CANOPY
AEROSPACE

AM Ceramics Feature Recognition Demo

Charlie Fuller
7/28/23

C00001 – bad candidate for printing/redesign required

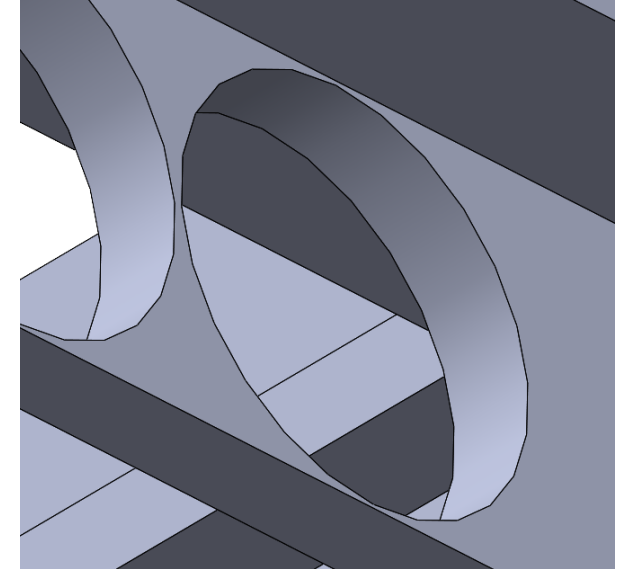
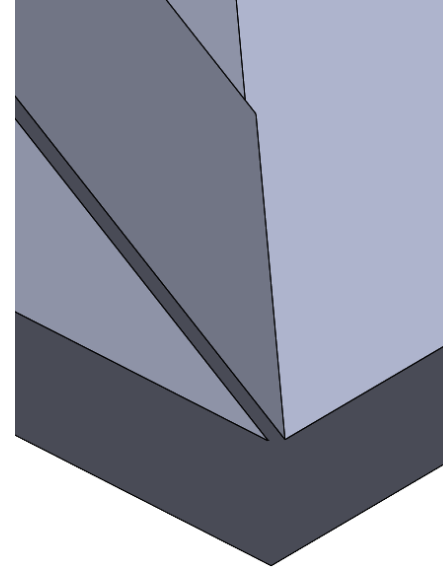
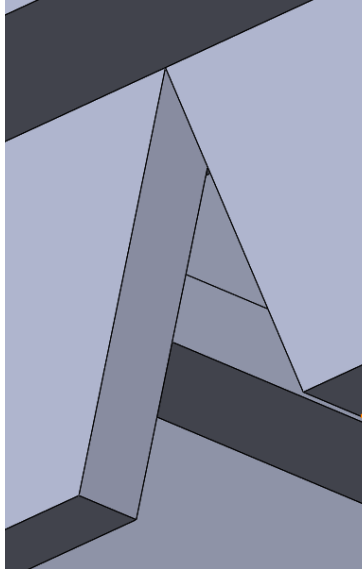
- Wall thicknesses $>10\text{mm}$
- Exceeds 350mm in one dimension
- Horizontal holes $>10\text{mm}$ with very thin walls near regions with cross sectional area change
- Unsupported overhangs around part
- No fillets, lots of sharp corners
- Not a 'complex' part, could be manufactured with something other than 3D printing

C00002 – good candidate for printing

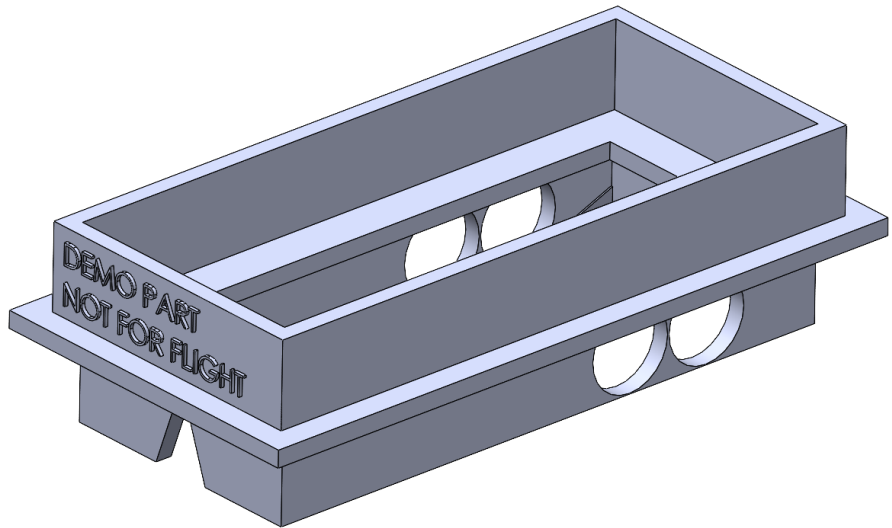
- Meets wall thickness requirements ($0.4\text{mm} < t < 4\text{mm}$)
- Meets part volume requirements ($XY < 300\text{mm}$, $Z < 100\text{mm}$)
- Fillets on all re-entrant angles
- No sharp overhang angles requiring supports
- Sufficiently 'complex' to warrant printing
